Addendum No. 3

City of Coquitlam

Tender No. 77522

United Boulevard Multi-Use Pathway

Project	UNITED BLVD 270m W OF KING EDWARD ST TO 140m W OF KING EDWARD ST
Description	ROADWORKS - PLAN & PROFILE
File	21-0536-R1
REV.	A

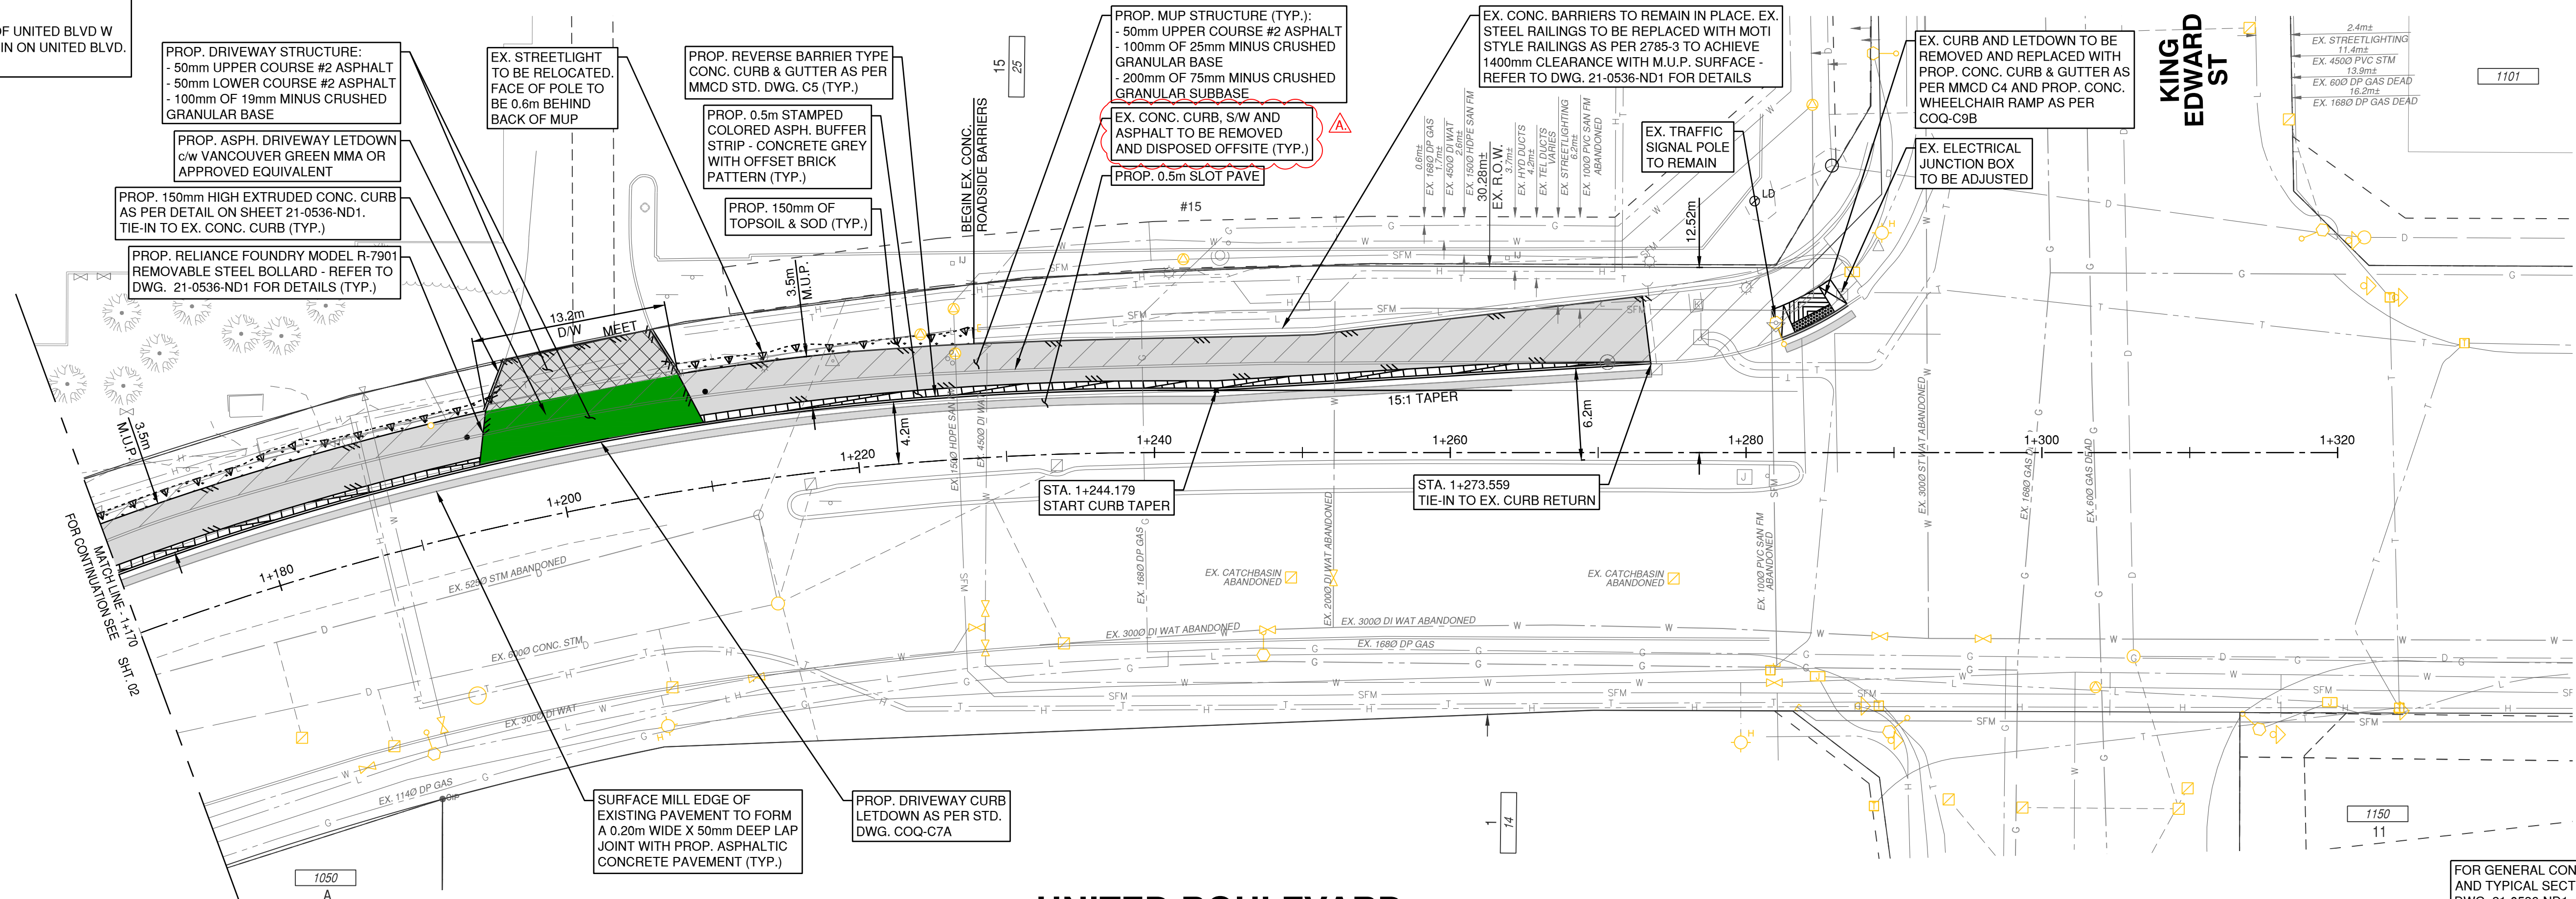
ROADWORKS – PLAN & PROFILE	02 of 06	21-0536-R1	3	2022-03-29
ROADWORKS – PLAN & PROFILE	03 of 06	21-0536-R2	3	2022-03-29

- Q1) Please confirm scope included in Item NO. 5.01 "Removal and Disposal of Existing Concrete Sidewalk and Existing Asphalt (all Depths), including asphalt curb" as it appears there is a discrepancy between the drawings and the schedule of quantities.

ROADWORKS – PLAN & PROFILE	02 of 06	21-0536-R1	A	2022-05-06
ROADWORKS – PLAN & PROFILE	03 of 06	21-0536-R2	A	2022-05-06

- A1) See revised SOQ and drawings included in this addendum.**
- Q2) How will the removal and disposal of contaminated material be dealt with on this project? (i.e. Contaminated ballast and subgrade material from leaching of creosote railroad ties)
